CITY OF WARRENTON

To: Warrenton Planning Commission
From: Skip Urling, Community Development Director 
Re: Side Design Review 17—3—Tract A/Forest Rim Apartments—Dick Krueger

Regarding: Forest Rim Apartments – Taxlot Key 81027DD00100 – Planning Submittal

HAMMERHEAD TURNING MOVEMENT DETAIL
SCALE: 1" = 30'

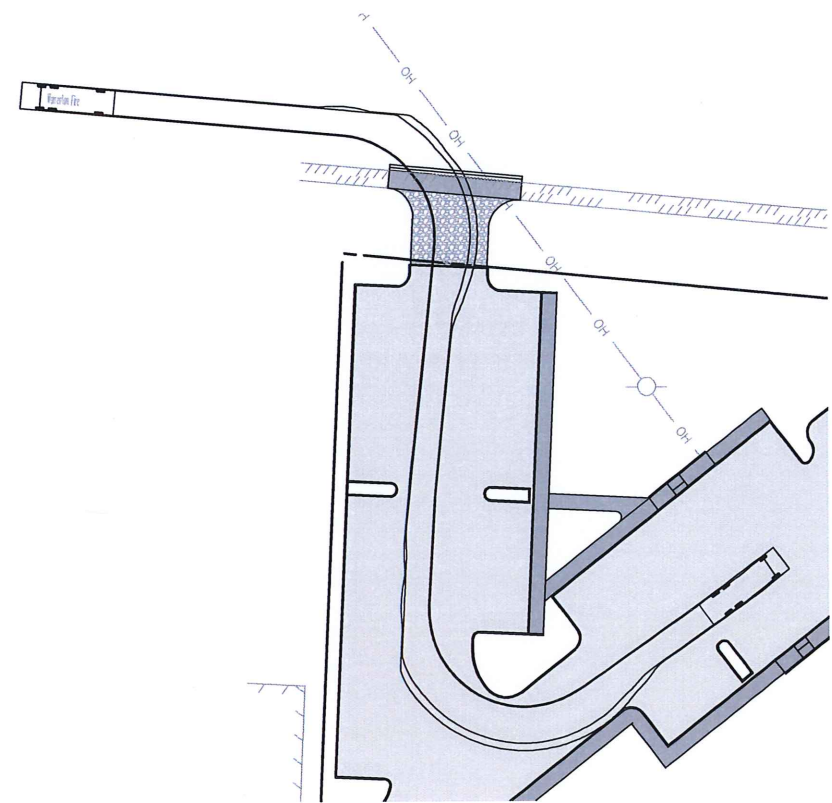
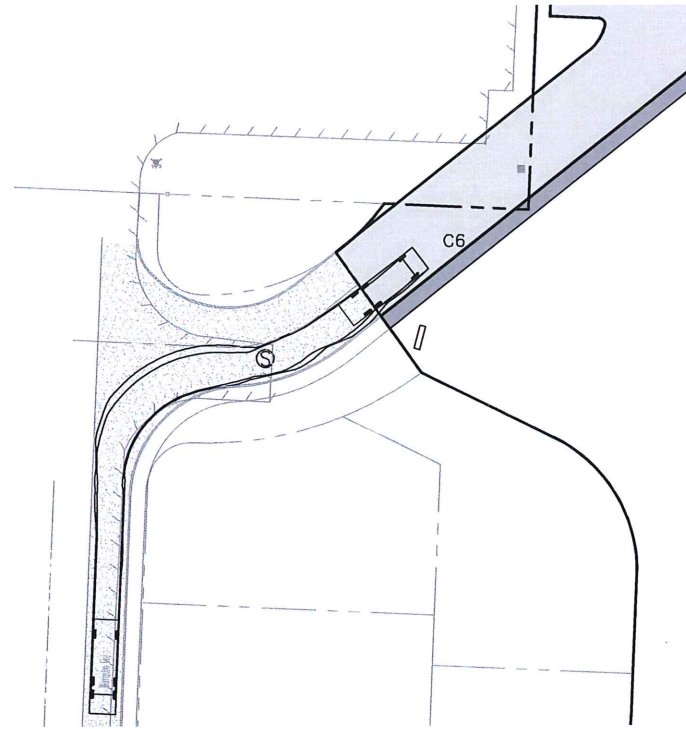
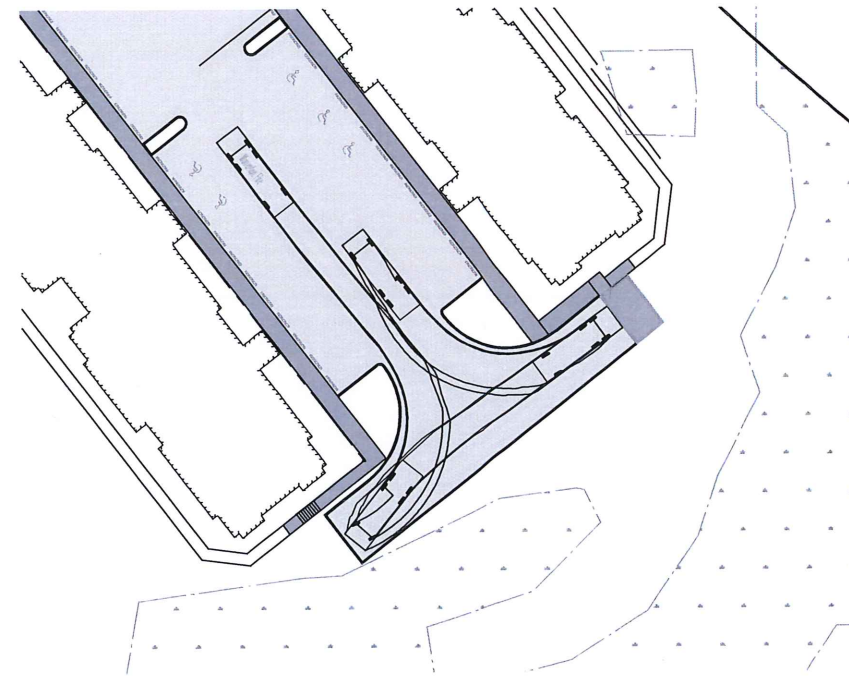
The proposed alternative hammerhead will provide an adequate turn around. The entire alternative hammerhead must have all of the curbs painted red and No Parking, Fire Lane signs installed at pre-approved, regular intervals. The Fire Department is not in favor of the refuse container in the proposed turn around location.

The Chokeberry access to the Food Bank would have to be brought up to an acceptable street standard for the Fire Department before an access from the proposed Snowberry Lane would be considered. Currently the site plan shows an acceptable emergency access point off SE Ensign Lane provided the structures are sprinkled and alarmed. However, it would be preferred that this development have two separated access and egress points.
